## Official Notification Federal Boat Safety Act – Steering Arm 3.0 Litre

MERCURY/MARINER  
225/250 HP, 3.0 LITRE (Carb/EFI) XL, CXL, XXL, & CXXL  
200/225 HP, 3.0 LITRE (Optimax) XL, CXL, XXL, & CXXL  
S/N 0G644802 Thru 0G870075

- a - Attaching bolt hole
- b - Steering link rod
- c - Attaching bolt

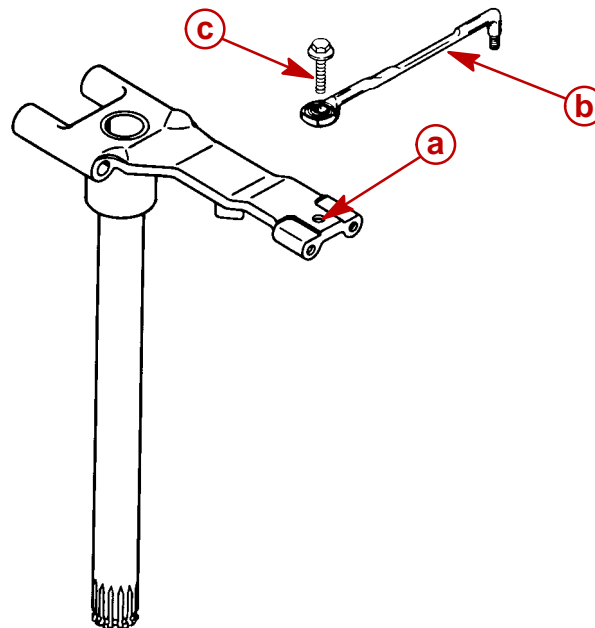
The steering arm attaching bolt hole, may be incorrectly chamfered. Under extreme steering torque conditions, this may cause extra strain on the link rod attaching bolt, which could result in bolt failure (steering disconnect). Breakage of the attaching bolt has not been reported on any standard production product, but as a precautionary measure, the standard attaching bolt should be replaced with a stronger, more durable bolt (See Parts Required).

Affected engines in the above serial number range should have the link rod to steering arm attaching bolt replaced with the stronger more durable bolt. Engines using OEM/after market steering systems may require various length bolts. Choose the correct bolt length from the following chart. Since the stronger more durable bolts are not offered with shoulders, engines using Teleflex clevis Kit P/N SA27314P with shoulder bolt, must replace the clevis with Quicksilver clevis kit P/N 70599A5, and also use the more durable bolt from the following chart.
